Wollongong Local Planning Panel Assessment Report | 6 November 2019

WLPP No.	Item 3
DA No.	DA-2018/1032
Proposal	Residential - Demolition of existing dwelling and outbuildings and construction multi dwelling housing and Subdivision - strata title - four lots
Property	18 Hopetoun Street, Woonona NSW 2517 Lot B DP 157627
Applicant	MMJ Wollongong (Luke Rollinson)
Responsible Team	Development Assessment and Certification – City Wide Planning Team (JW + JW)

ADDENDUM REPORT

SITE/ SITE ANALYSIS PLAN

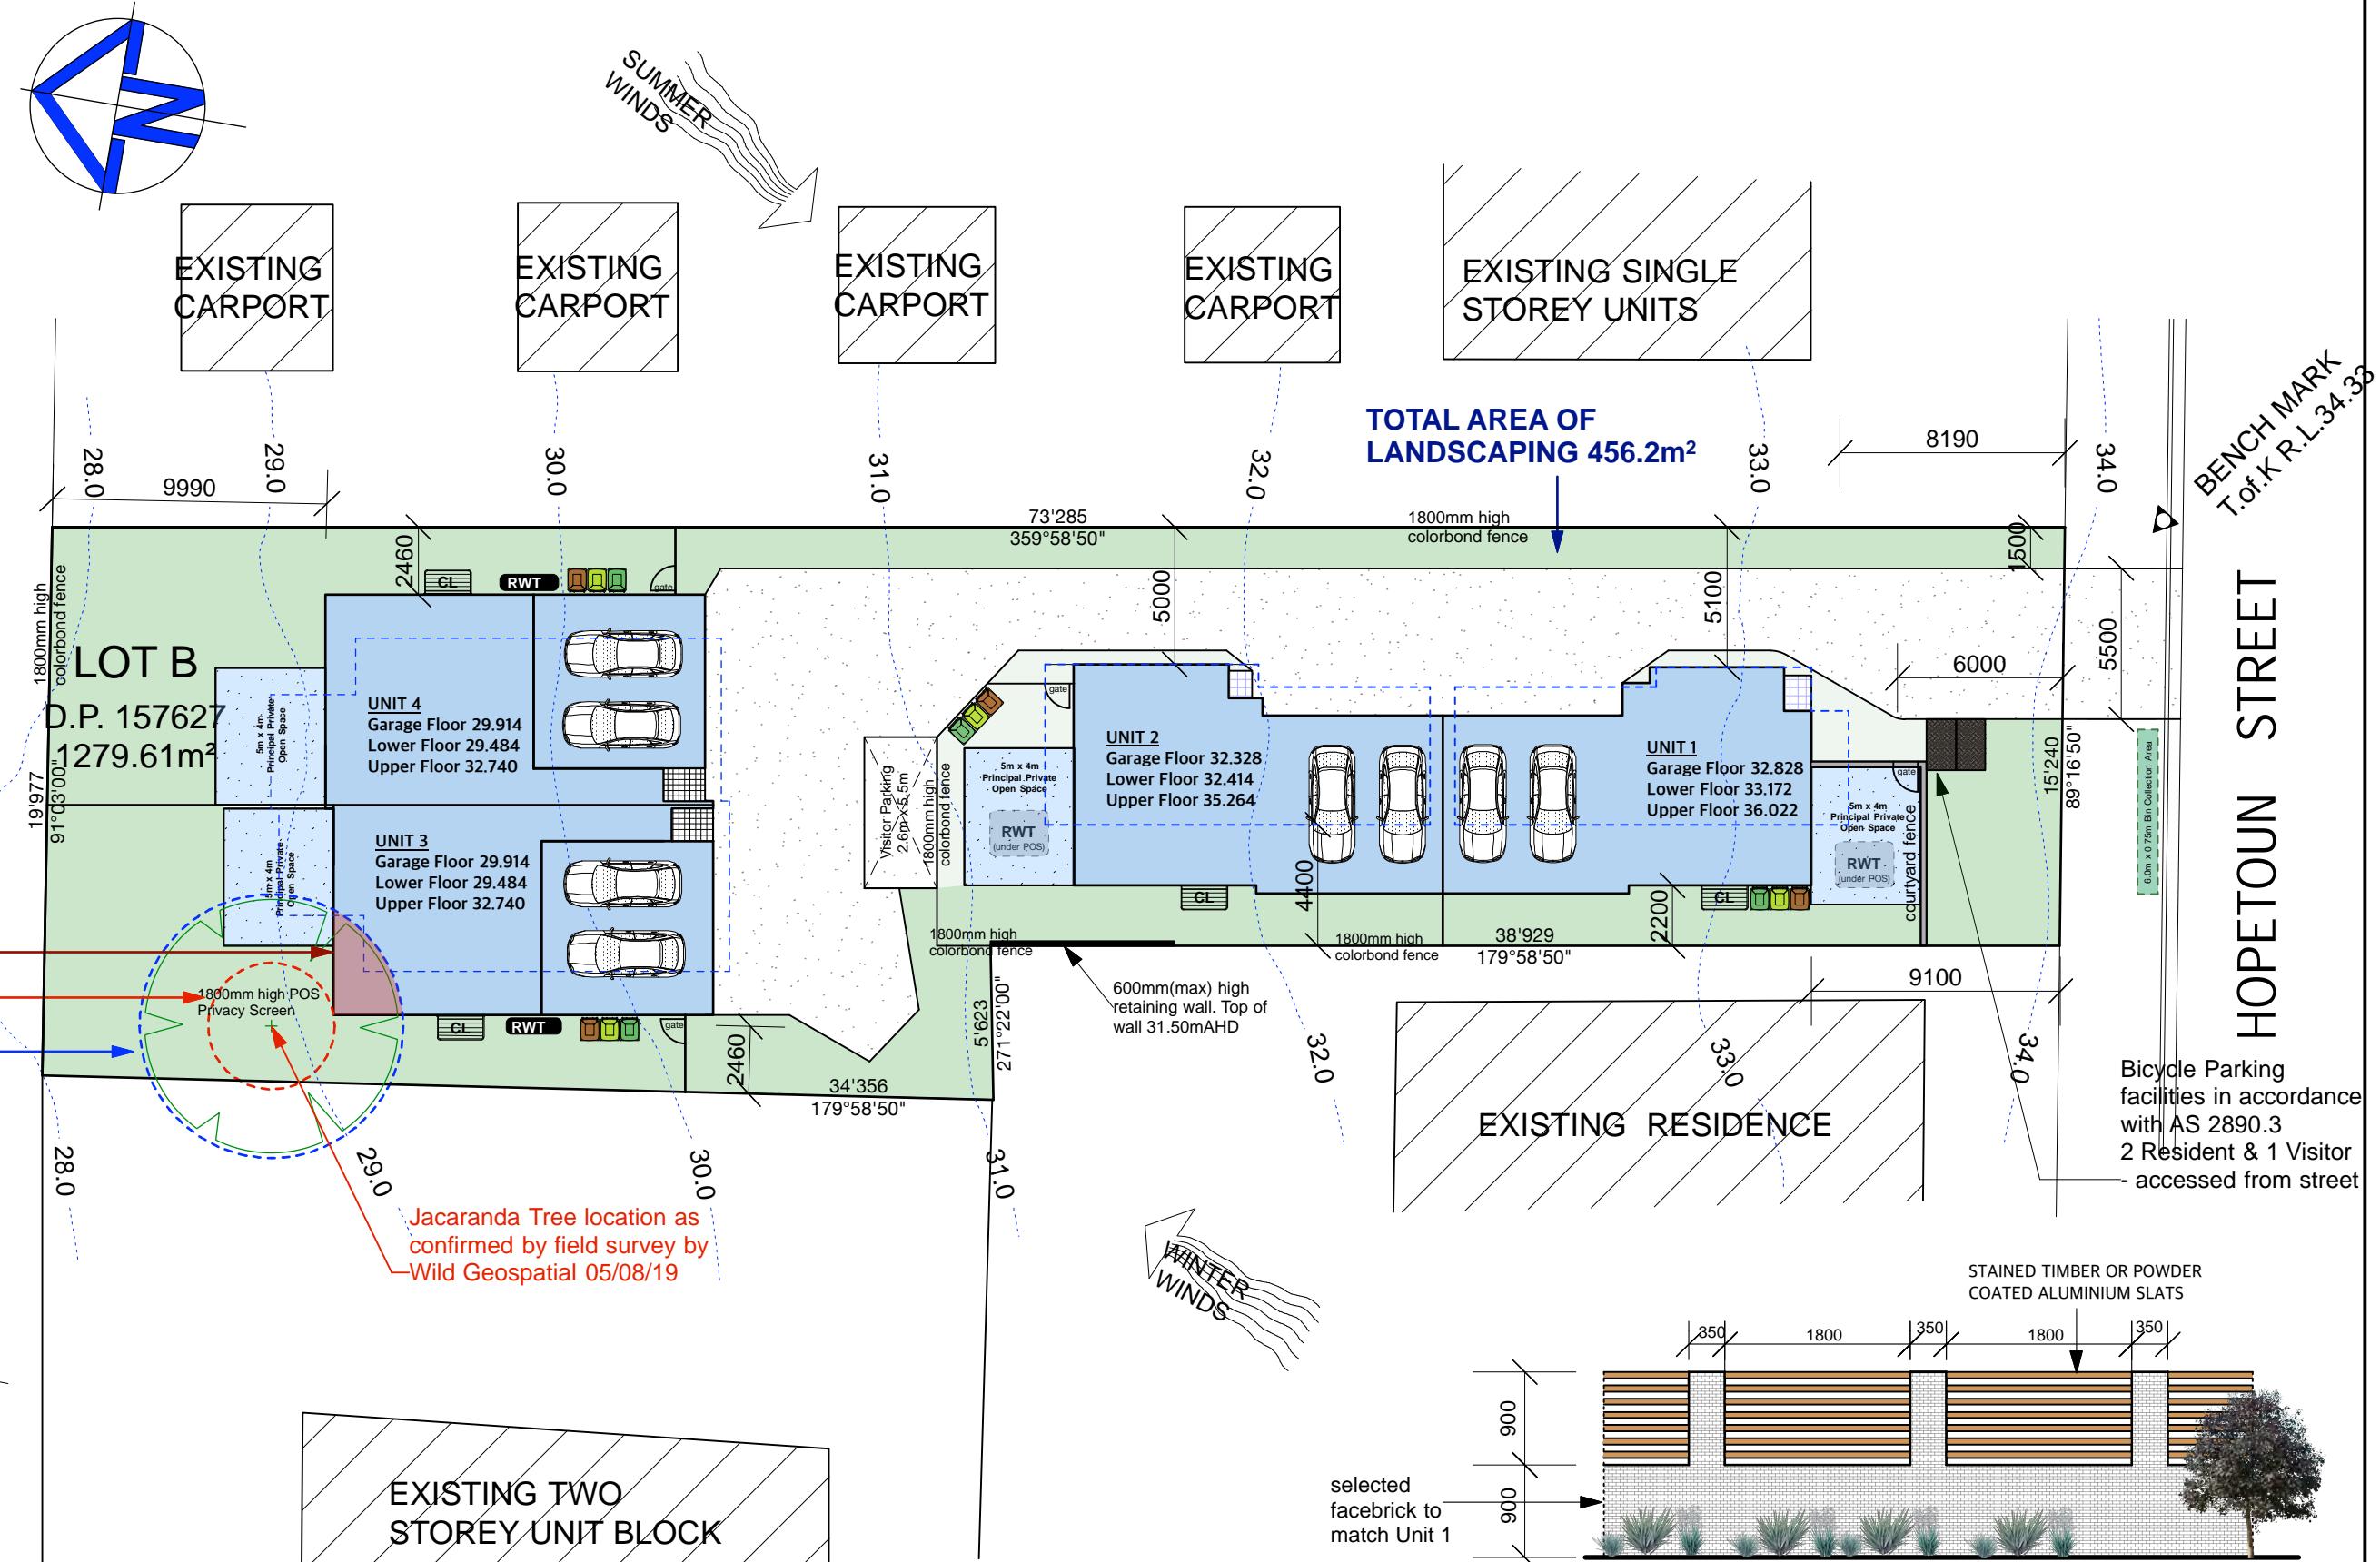
- *Long section through the whole site showing existing and proposed ground levels;*
- *Site plans that shows the building layout at ground and first floor in relation to all boundaries to include setbacks;*
- *RL's on all floor plans.*

As part of the Panels review it was apparent that the plans incorrectly showed the Jacaranda tree intended for removal. This is not supported by the Panel and requires redesign of the proposal. The Panel is of the view that the development has not yet adequately responded to the site constraints specifically in respect to the noncompliance to the minimum site width control.

- an updated Driveway Long Section Plan with finished garage ground floor levels for each dwelling;
- an updated Site Plan that shows both the ground floor and first floor building lines; and
- RLs on all floor plans for each level.

Encroachment: 15%; based on Sheet 3 of 21. The encroachment consists of the construction of the proposed unit 3 (nine percentage points) and also the principal private open space for unit 3, this being six percentage points. Construction and design methodologies for the principal private open space are unknown, although are nominated to be above grade and porous with the preference for retaining as a natural surface (eg. lawn), therefore any impact offered by this area is minimal. This will reduce the predominant impact to below 10%, that is a minor encroachment.

LOWER FLOOR PLAN

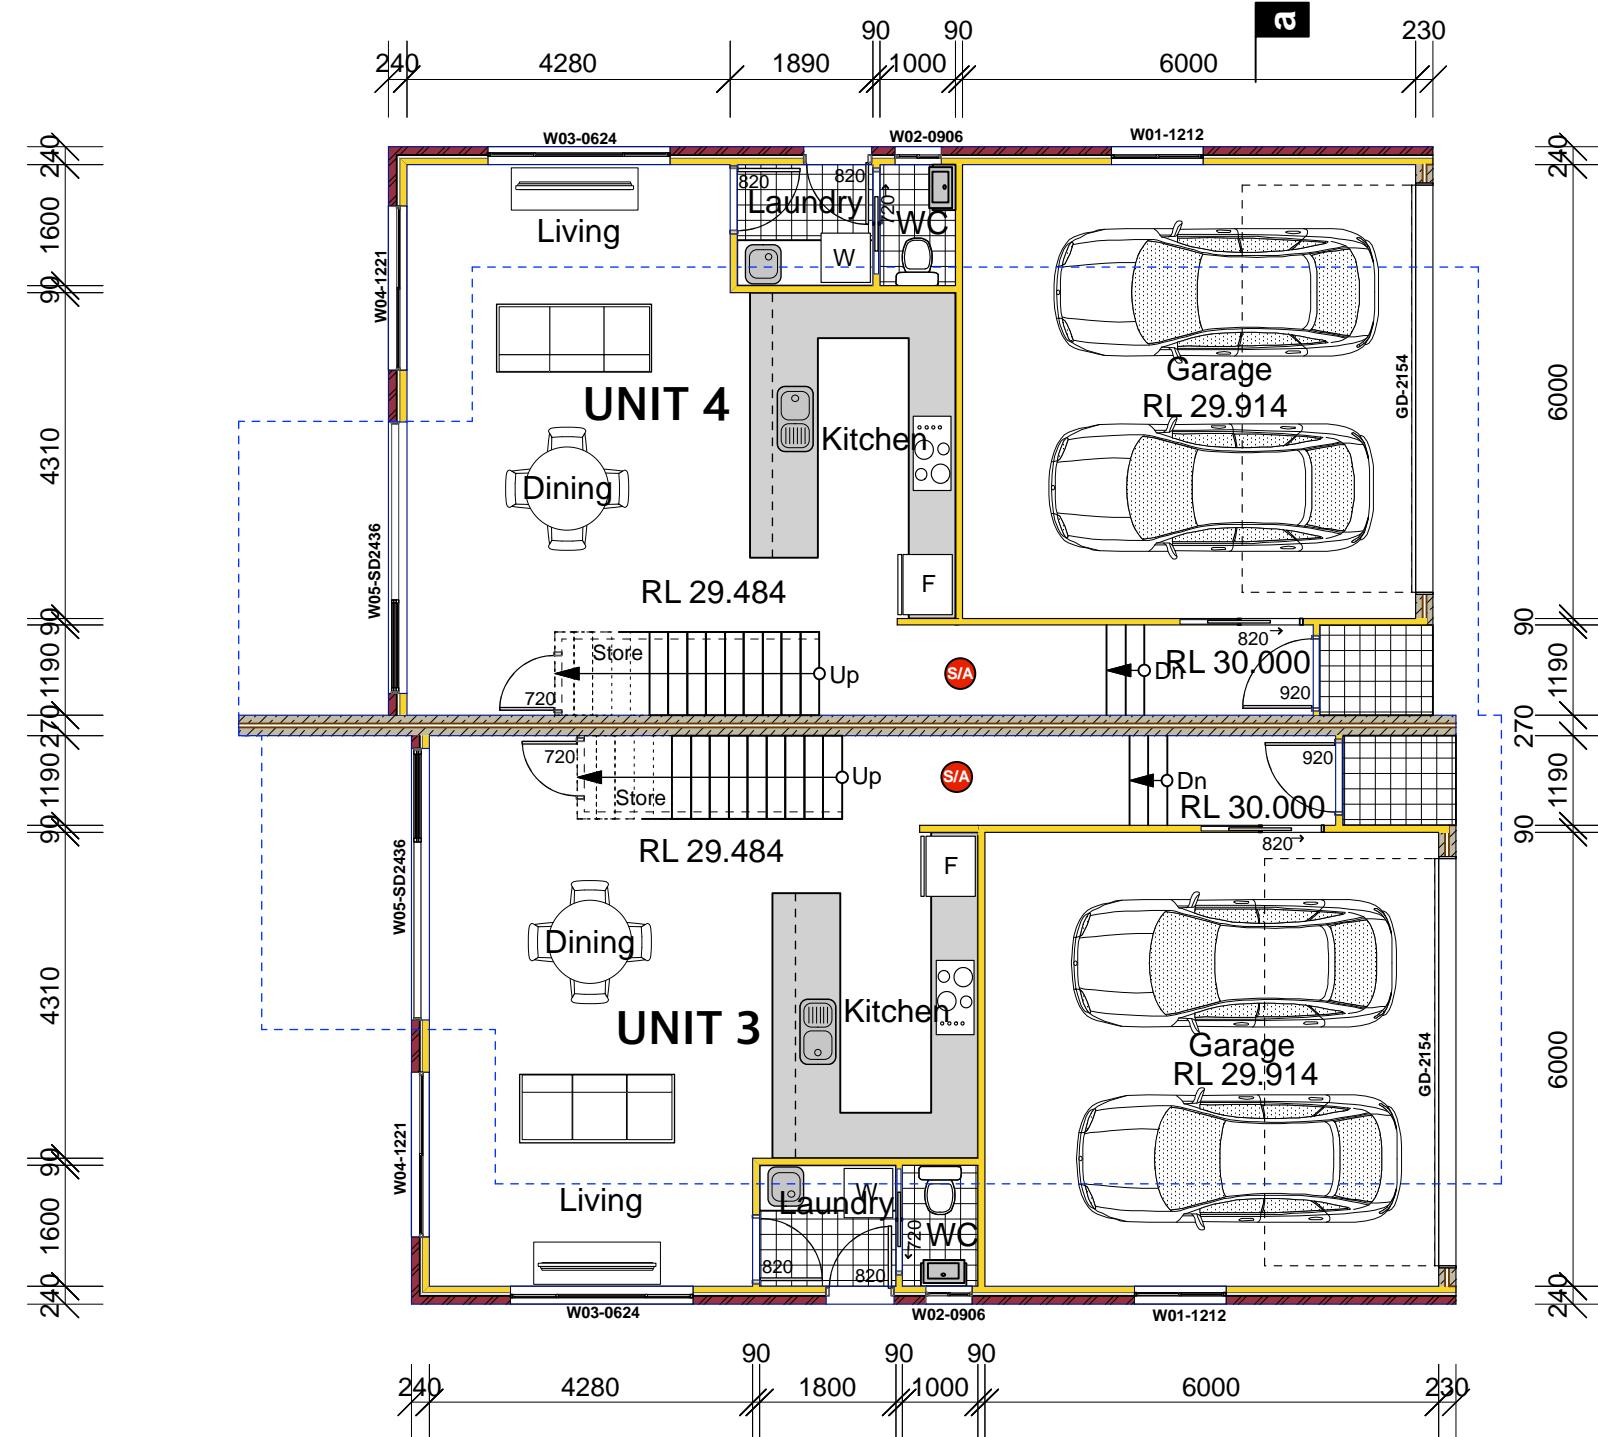
1. *Retention of the Jacaranda Tree in the rear yard. This will require the redesign of unit 3 and 4.*
2. *Improved presentation to the street which will require changes to window size and placement, colours and finishes.*

7. *Studies should be relocated to first floor or deleted to maximise living area.*
8. *The laundry and WC on the north elevation of unit 3 and 4 should be relocated away from the northern aspect.*

The design of Units 3 and 4 have been amended to ensure retention of the Jacaranda tree as requested, with the respective changes shown within the updated Architectural Plans by Ingenuity Home Design. The arborist report by Allied Tree Consulting has also been updated to reflect this change. Refer to amended documents as part of the resubmission package.

The laundry and WC within Units 3 and 4 have been redesigned and are shown within the revised Architectural Plans by Ingenuity Home Design.

Unit 3 and 4 have been redesigned to incorporate the retention of the Jacaranda Tree in the rear yard. The proposed design involves an encroachment into the Tree Protection Zone of greater than 10% however the majority of the encroachment is through the private open space which can be mitigated with conditions of consent for permeable paving or raised decking. Councils Landscape Officer reviewed the amended landscape plan and amended arborists report and was satisfied with the application, providing conditions of consent.

UPPER FLOOR PLAN

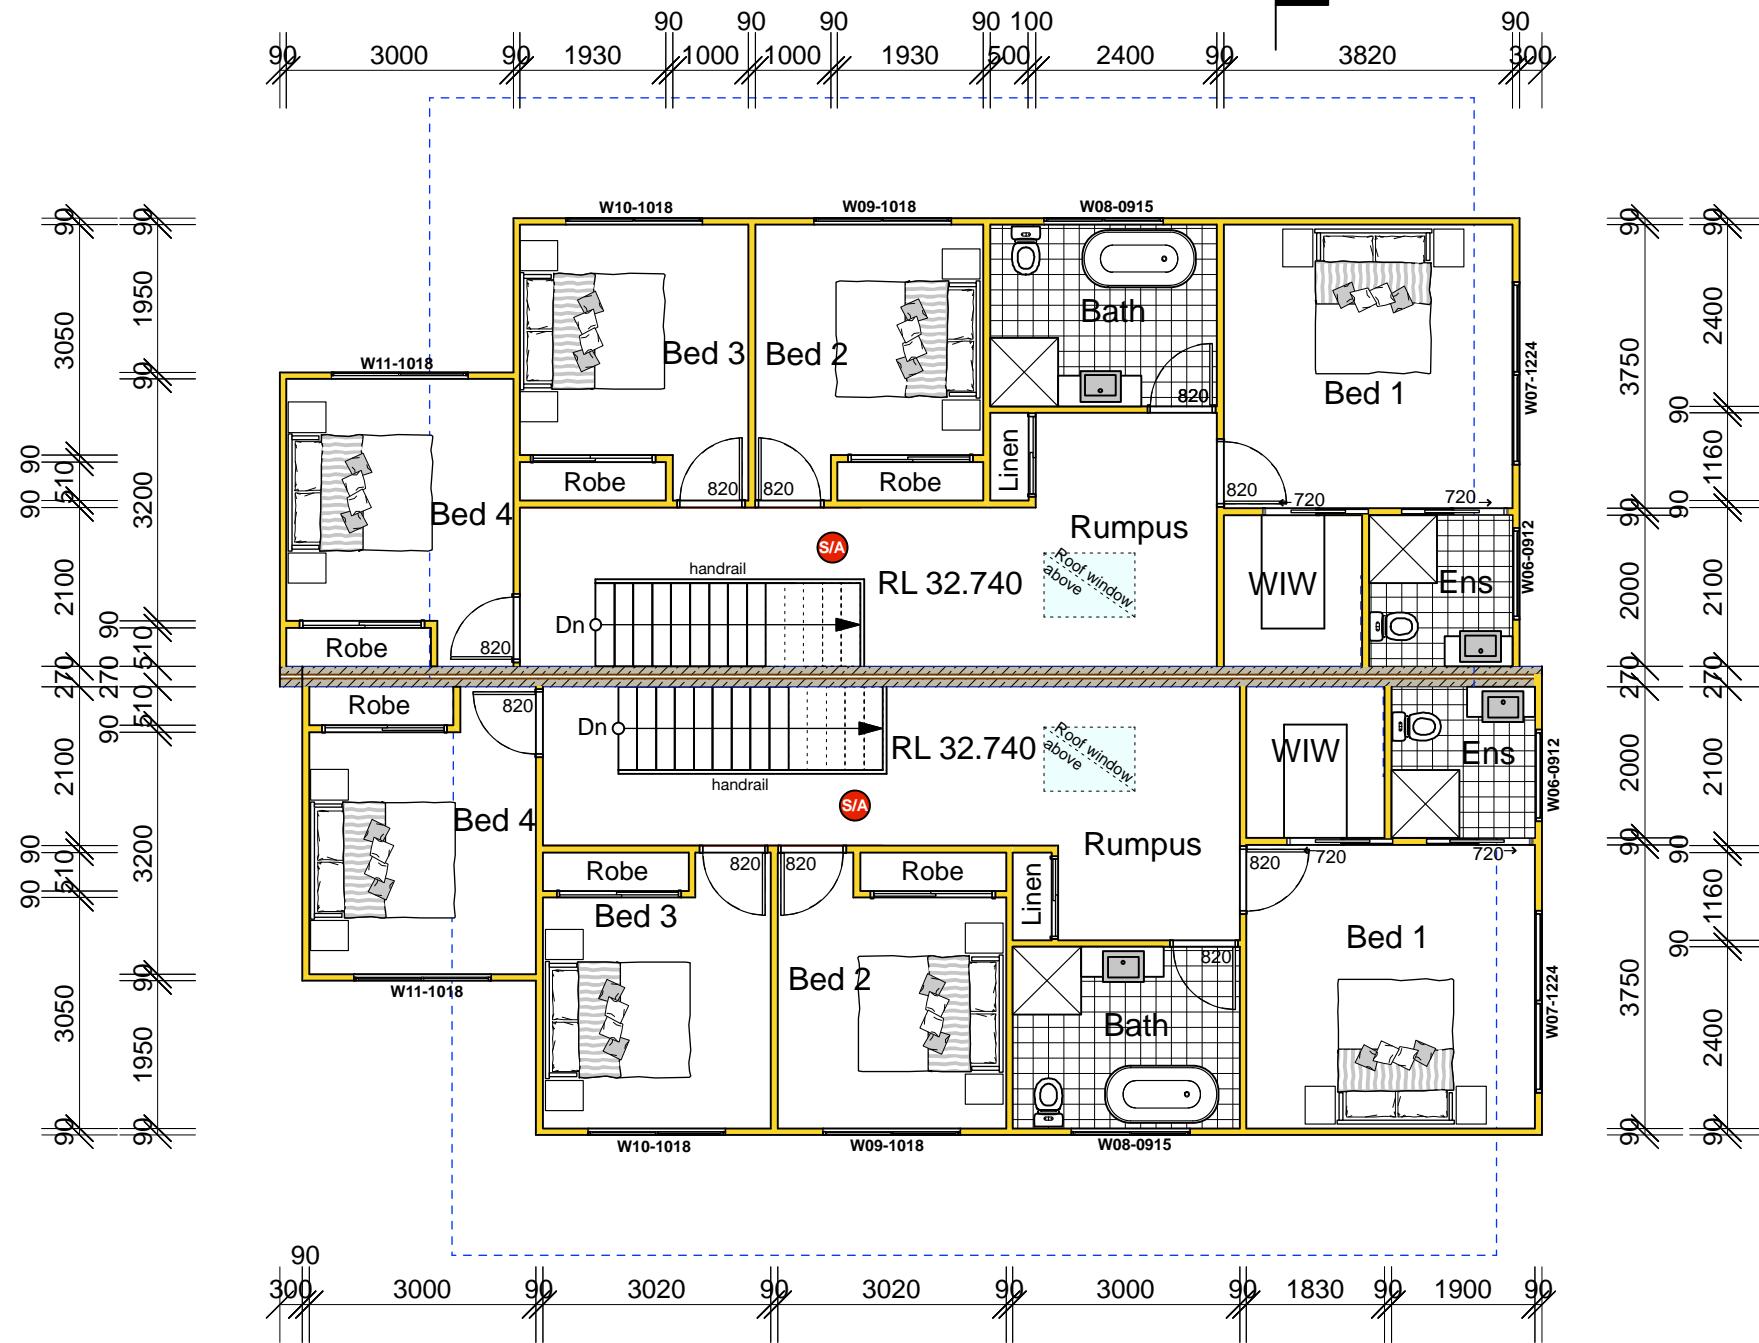
9. *Any upper level rumpus room should have access to light and ventilation.*
10. *Amendments that rectify mistakes on the plans such as ensuites not having doors etc.*

Roof windows/skylights have been added to the upper level of Units 3 and 4. Natural ventilation is achieved through crossflow from bedroom windows accordingly.

The upper level rumpus rooms have been provided with skylights, their location has not been moved to provide ventilation without the opening bedroom 4 and 1 of units 3 and 4 for crossflows.
